TECHNICAL EVALUATION REPORT ON DUKE FOWER COMPANY'S MCGUIRE AND CATAWBA NUCLEAR STATIONS SAFETY PARAMETER DISPLAY SYSTEMS

TAC NUMBERS 51254, 51255, 50413, AND 50414

August 19, 1987

Science Applications International Corporation

Alarm Video Layout With Safety Parameter Display

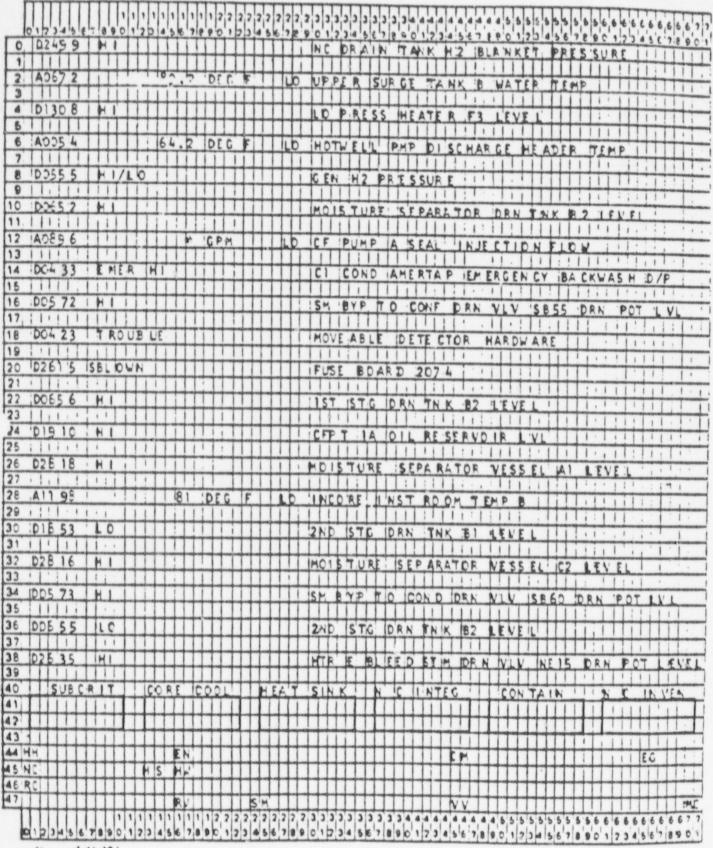
- 6. The OAC Alarm Video list that is displayed above the CSF blocks on the top level display is not considered part of the "formal" SPDS. However, if the licensee proposes to use any of this information to meet SPDS requirements, the following HEDs are applicable:

- a. The Alarm Video display does not provide any indication of existing alarms that cannot fit on the display page. The operator may not be aware of or may not remember existing alarms.

- b. The Alarm Video display provides no means for bringing up and viewing alarms that do not fit on the display page. These alarms cannot be viewed until alarms already on the page have cleared.

- c. Letter designations for the systems in alarm are provided below the CSF blocks at the bottom of the Alarm Video display. However, the audit team found inconsistencies between the system letter designations displayed on the OAC and a hard copy list of system letter designations.
